Office Action Summary

10/630,039

BERMAN ET AL.

DETAILED ACTION

Fig. 3

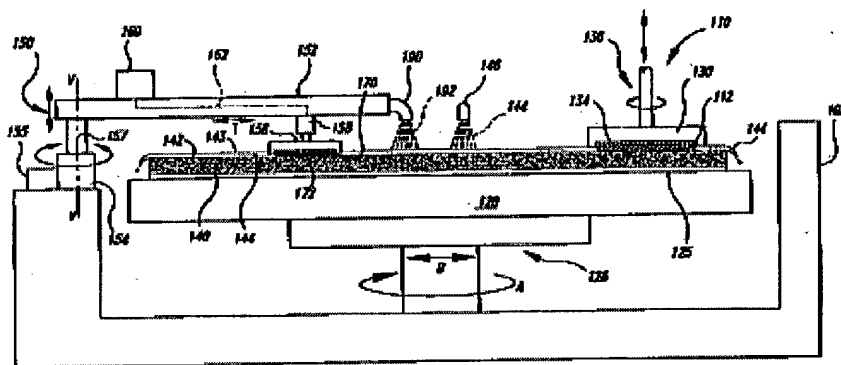
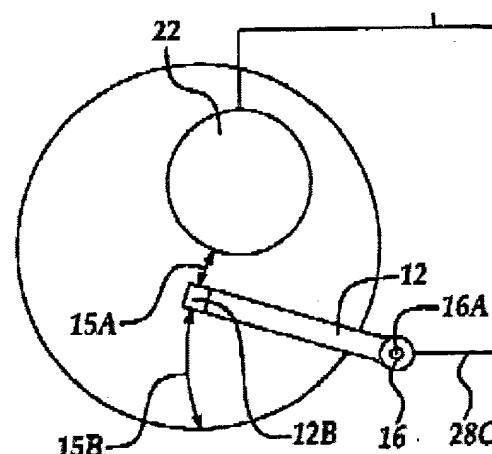
Southwick discloses all of the limitations of claims 1 and 11, i.e., a method of and an apparatus for wetting a semiconductor wafer, said method comprising using a wafer carrier (130) to hold the wafer to a polishing pad (140); dispensing a chemical (192) through at least one outlet (190) to the polishing pad; and moving the at least one outlet while dispensing the chemical.

Regarding claims 3-5, 7-10, 12-4 and 16-18, Southwick meets the limitations, e.g., arc and back and forth motion (rotational and up and down movement 04:38-54); rotating the carrier or the pad; movable arm (152) carrying the outlet and movable in arc or up and down motion.
